ZBA 15-10

A variation to increase the permitted height of a fence from six feet (6') to eight feet (8').

EXHIBIT A: RESPONSE TO STANDARDS AS PREPARED BY THE PETITIONER

Figure 1

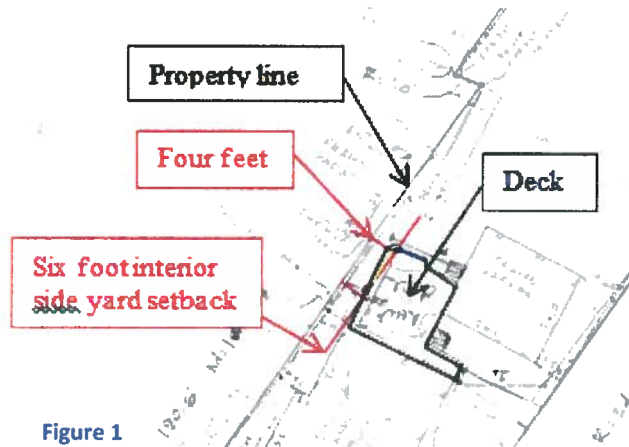
Staff finds that the petitioner’s lot does not have unique physical limitations however the placement of the existing structure impacts the placement of the deck within the required side yard setback.

1. The alignment of the house is not square with the property lines. Approximately half of the deck screening is allowed per code however the other half encroaches into the side yard setback due to the alignment of the house sitting at an angle. The yellow portion depicted in Figure 1 is the nonconforming area.
2. The proposed improvements will not adversely affect this or other properties in the neighborhood and will be consistent with the existing structure and surrounding neighborhood. The deck is adjacent to the neighboring property's garage and driveway. The proposed deck is replacing an existing deck however a permit for the existing deck could not be located within the Building Division files. Therefore, it is unknown how long the existing deck has been present on the property.
